EPC STORMWATER REVIEW COMMENTS ARE SHOWN IN ORANGE BOXES WITH BLACK TEXT

# PAINT BRUSH HILLS METROPOLITAN DISTRICT SCENIC VIEW AT PAINT BRUSH HILLS POND MODIFICATIONS

MAY 2022

SCENIC VIEW AT PAINT BRUSH HILLS POND MODIFICATIONS, RGA PROJECT NO. 1070.0022

DRAWN BY: JGS  
 DESIGNED BY: GEW  
 JOB NUMBER: 1070.0022  
 DATE: MAY 2022  
 SCALE: 1" = 20'  
 DRAWING NAME: GRADING PLAN  
 SHEET NO: 3 of 8

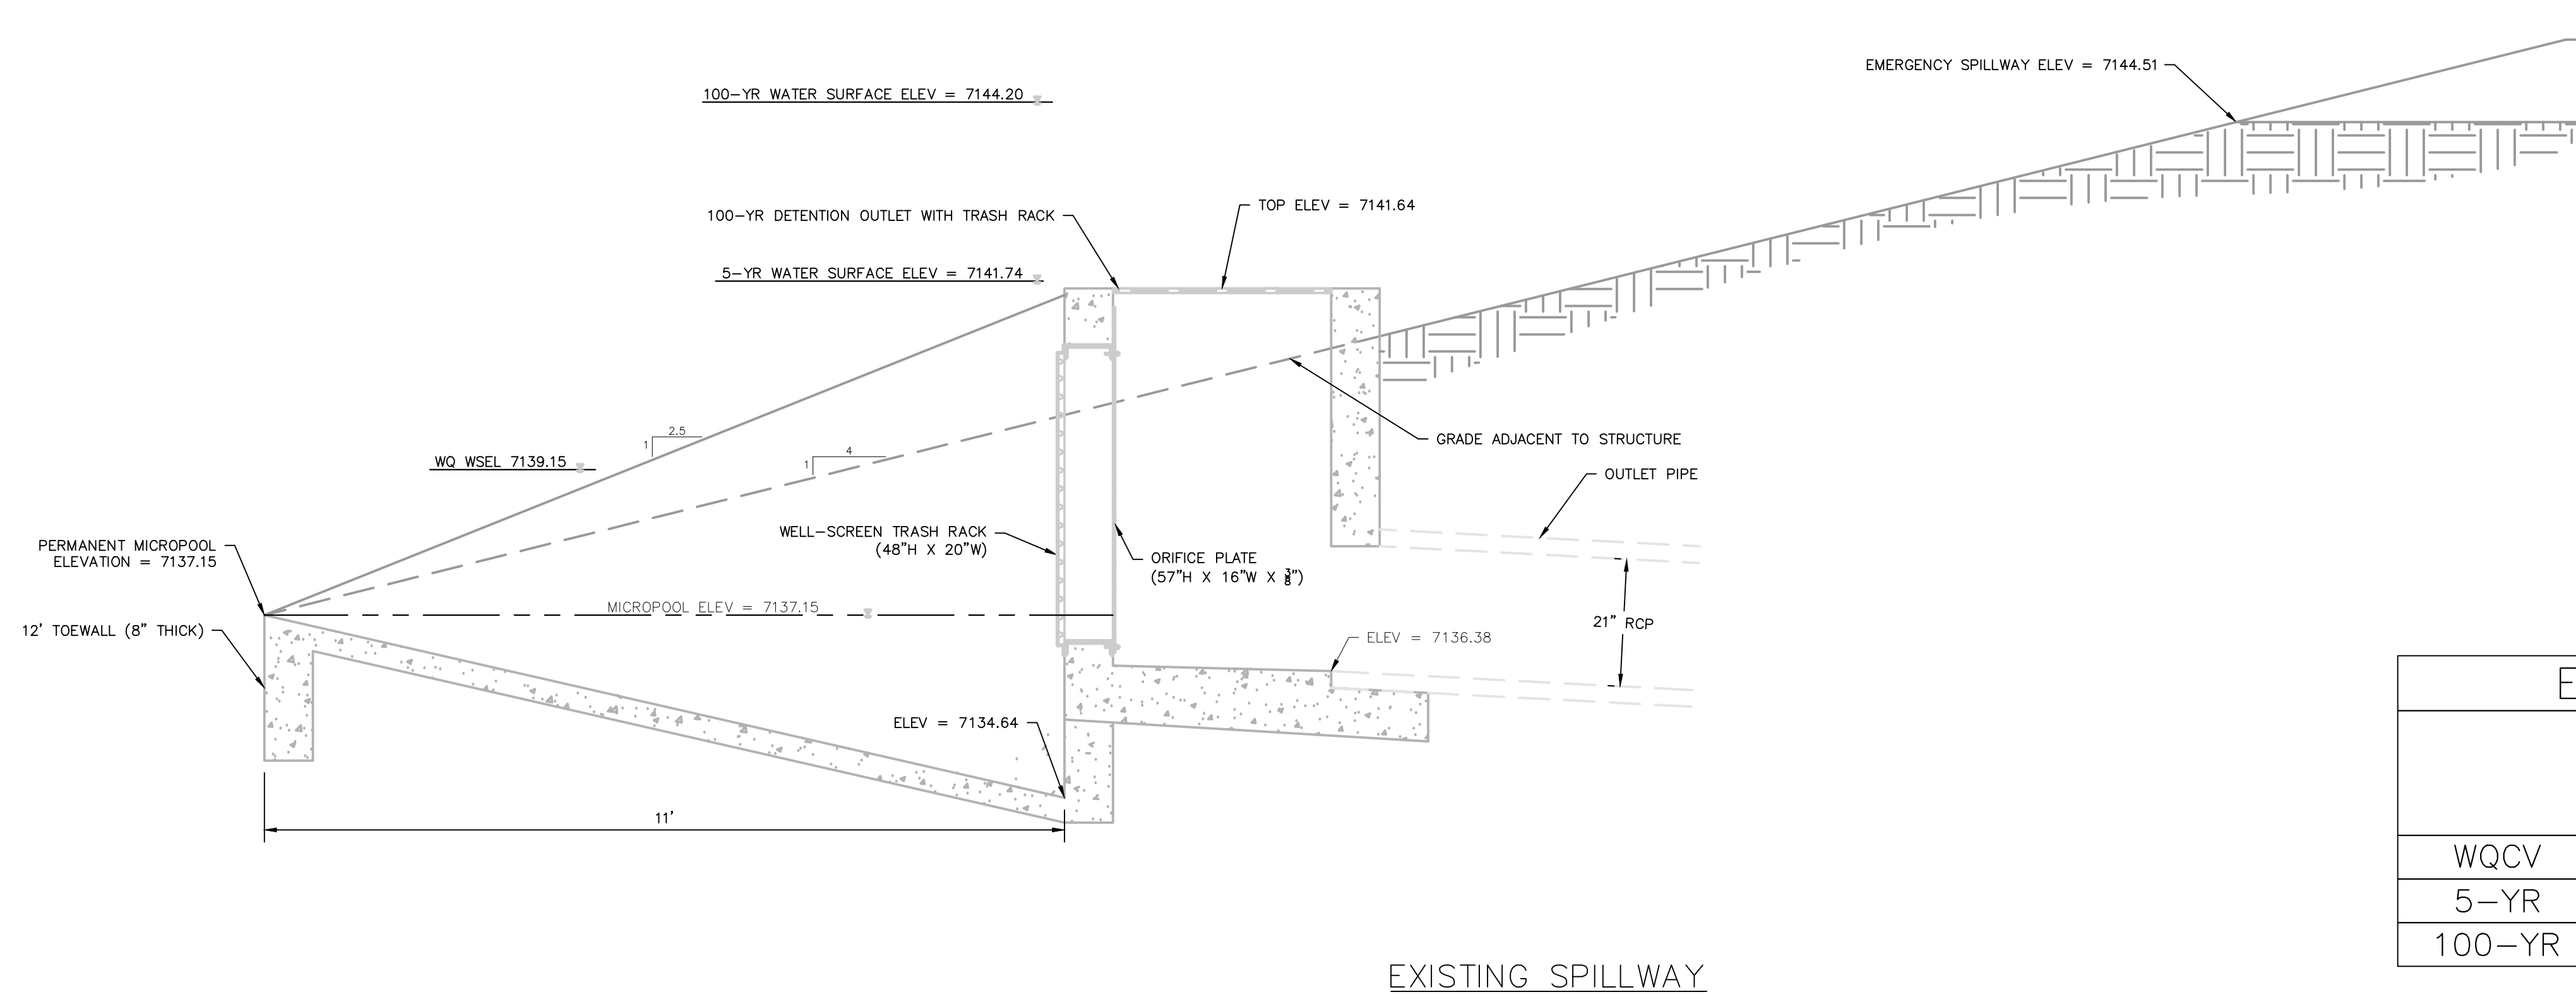
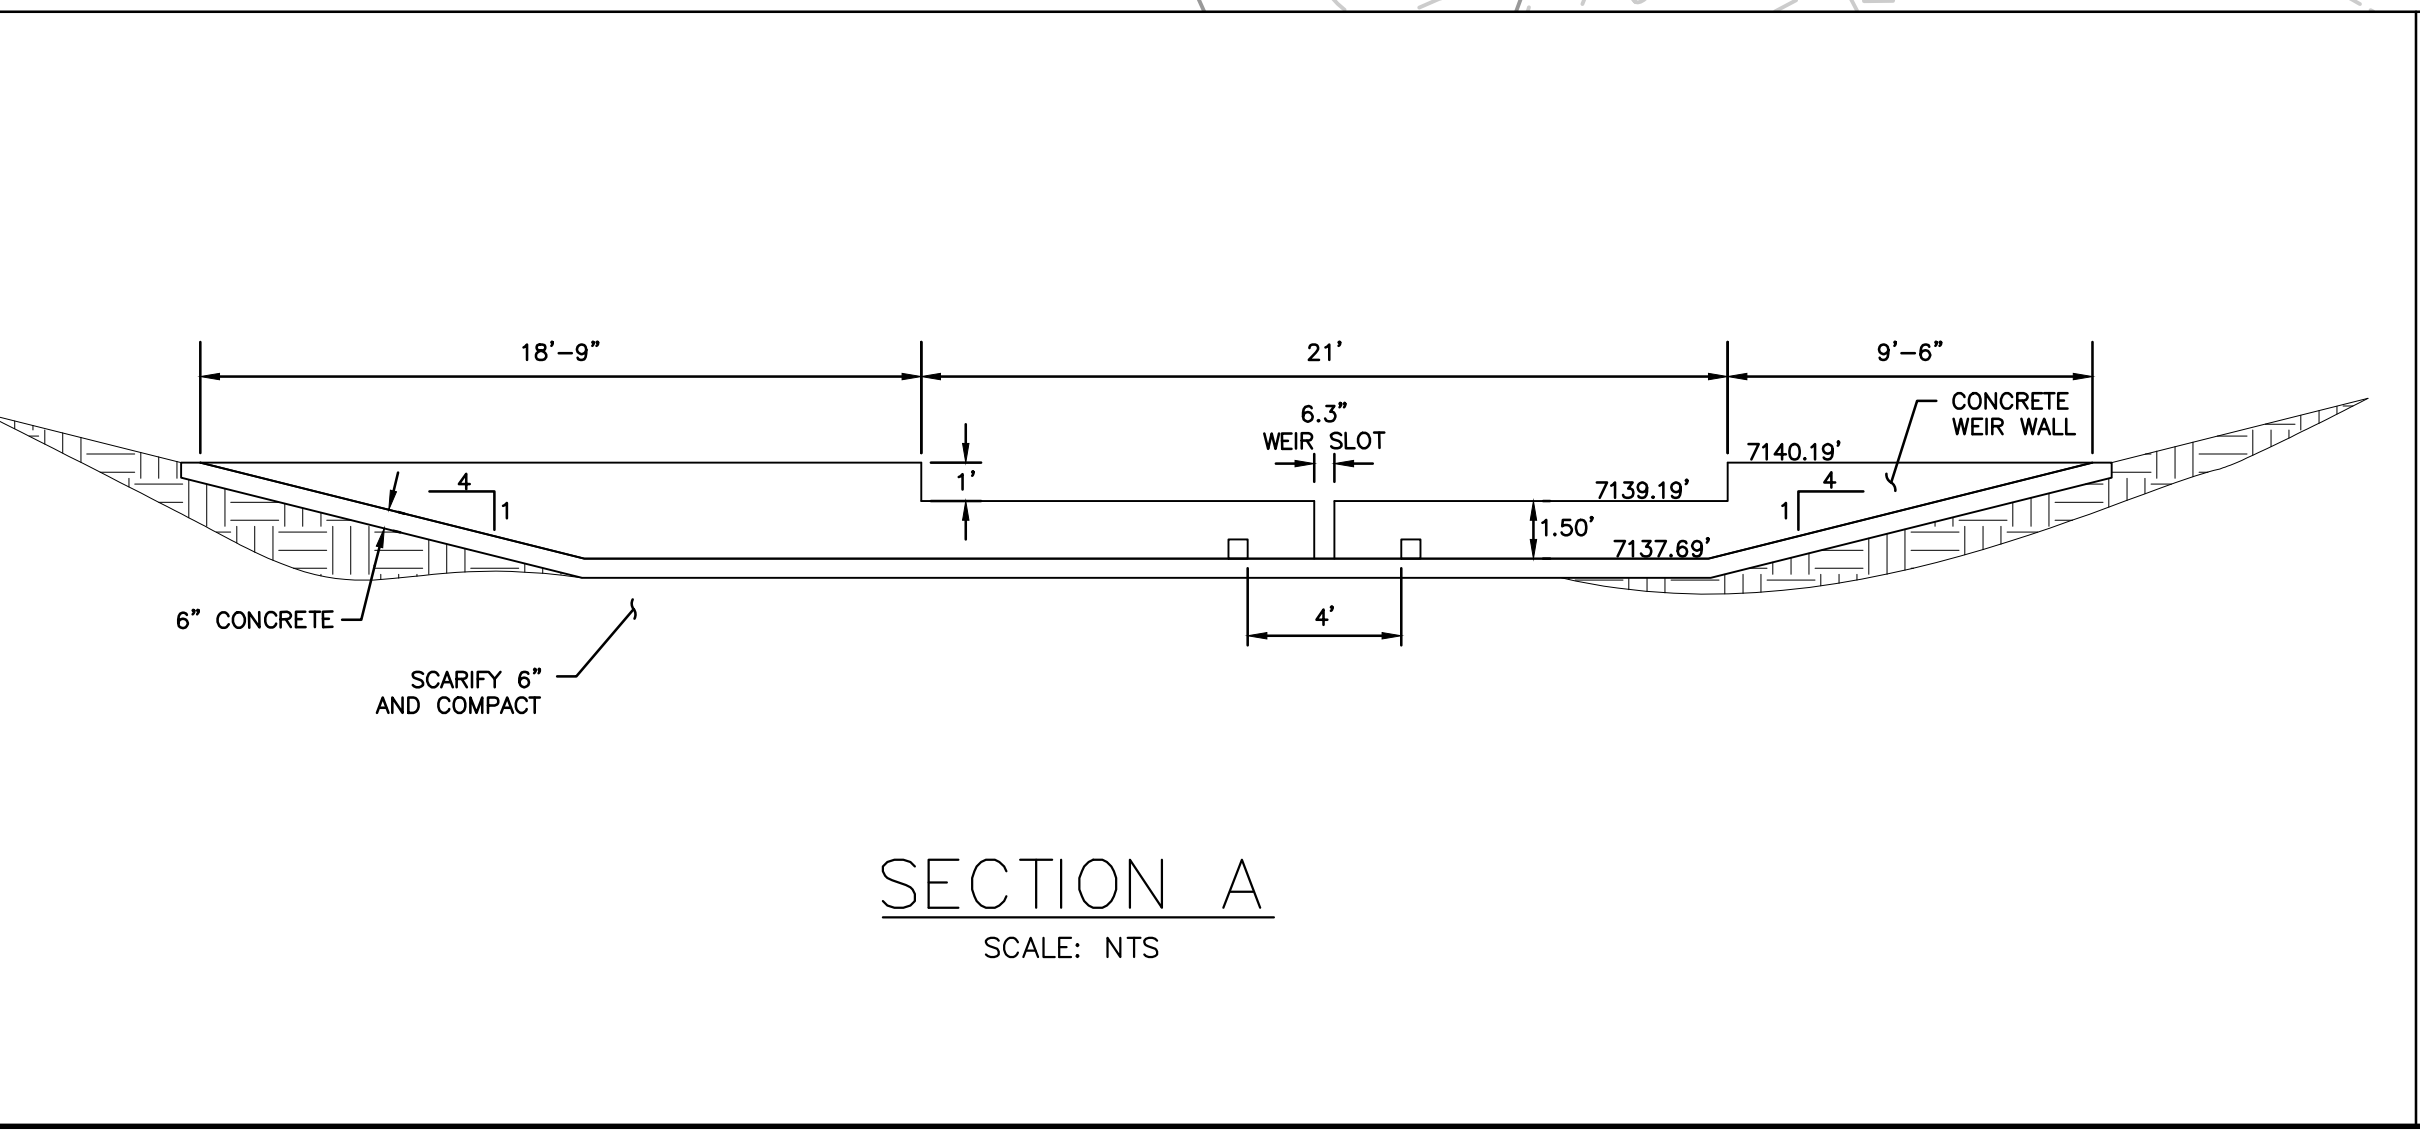
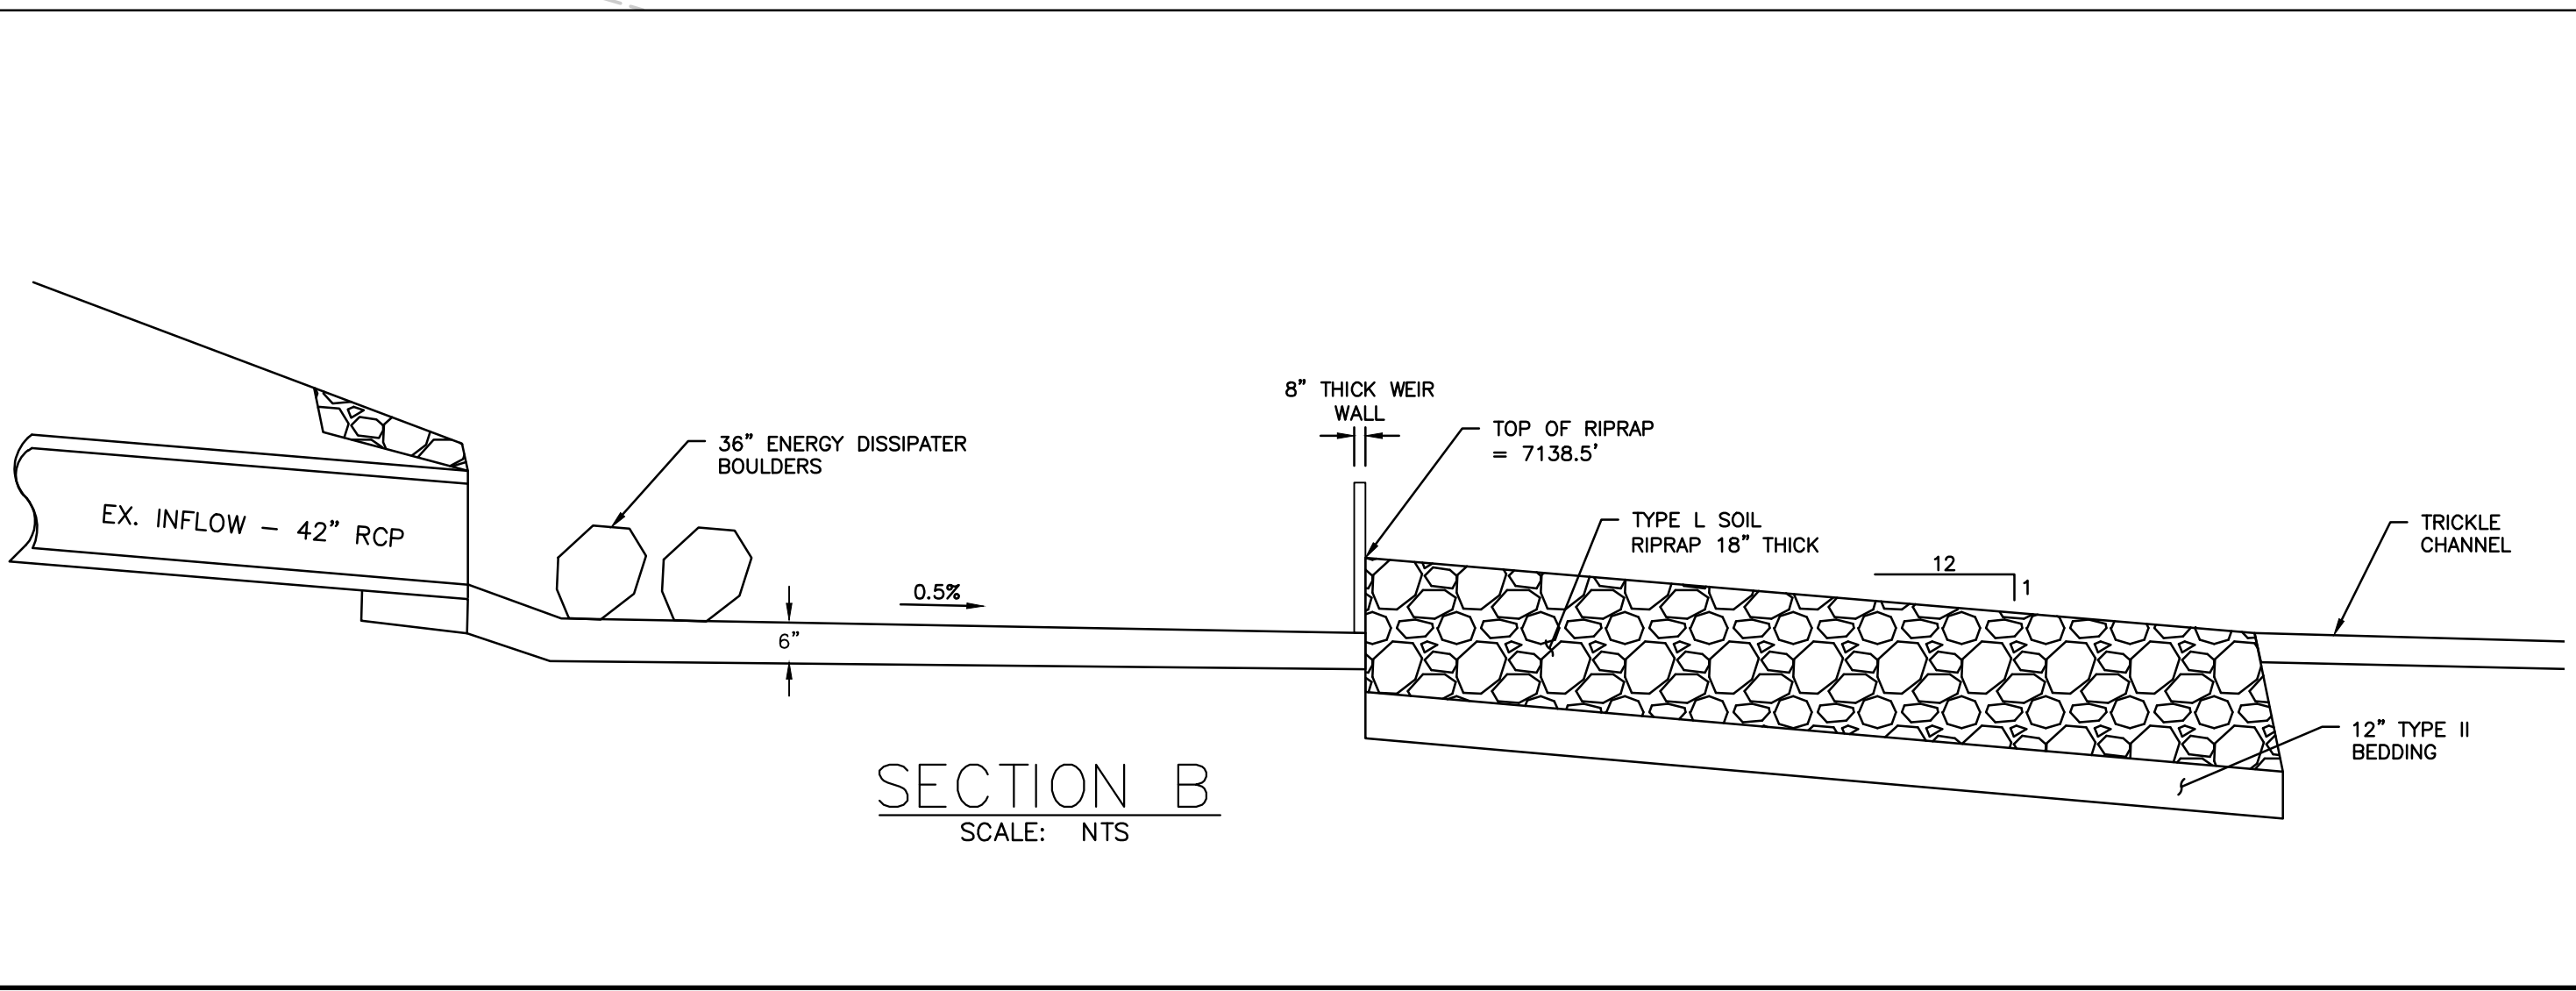
add property lines to legend or call out on figure  
 add all existing and proposed easements  
 show construction site boundary  
 show limits of disturbance  
 note: If "limits of disturbance" and "construction boundary" are the same, you can use one line type and label it "limits of construction/disturbance" or otherwise show as separate line types for each on the legend and figure.  
 Show areas of cut/fill  
 Show stormwater flow arrows

Label adjacent subdivision name

Label subdivision name

Label adjacent subdivision name, and property parcel numbers

TRICKLE CHANNEL - TYP. SECTION

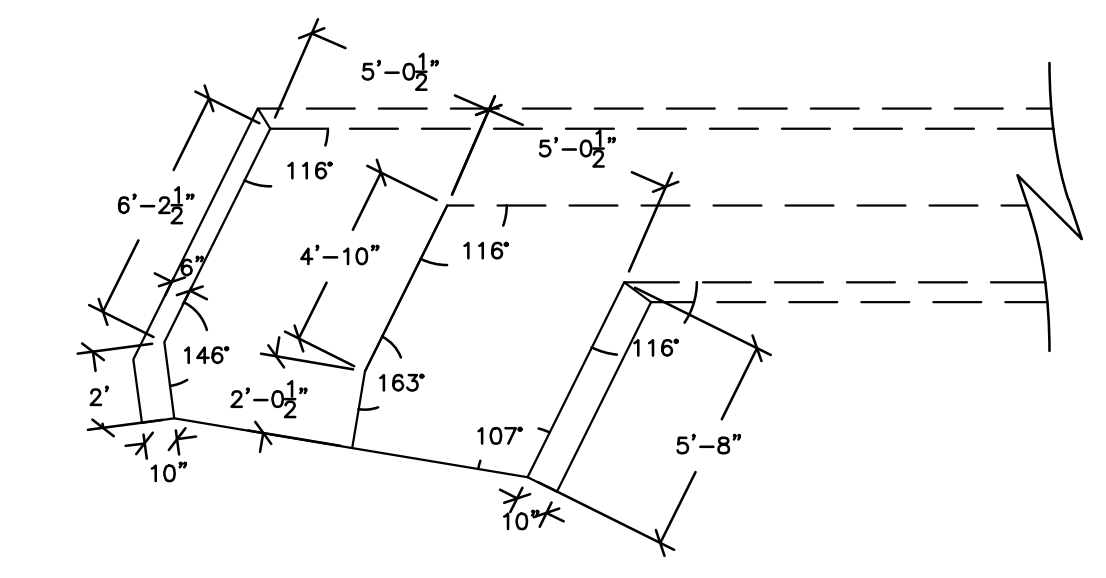
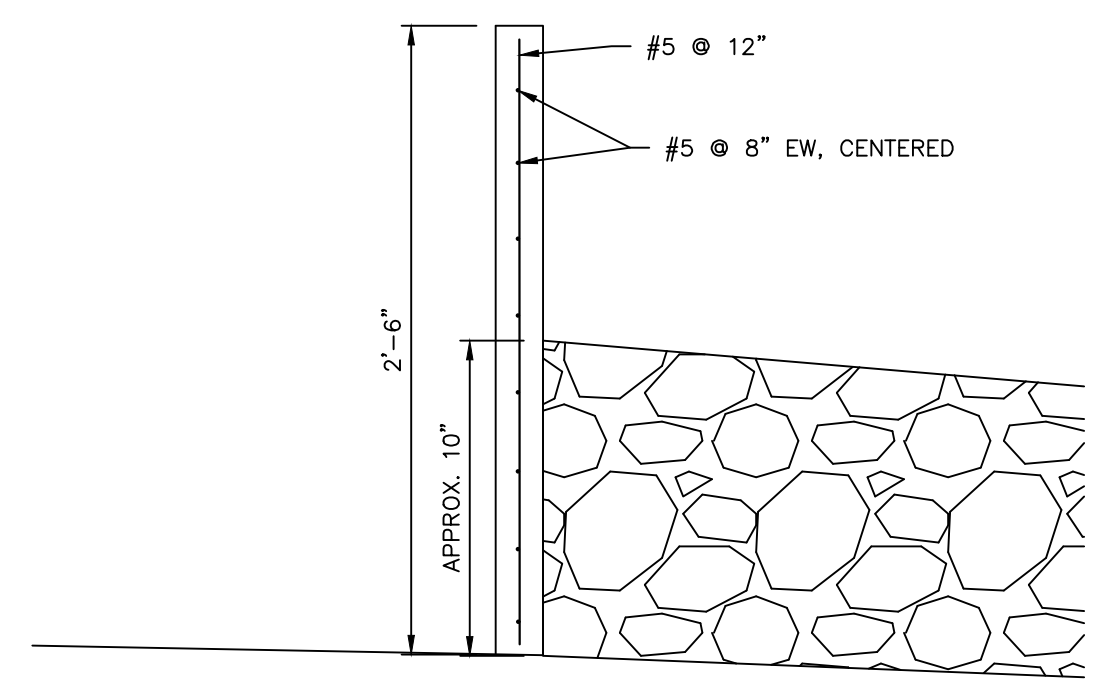
Pond bottom should have a minimum slope of 3% to the trickle channel and micropool (USDCM Vol 3, detail T-5).
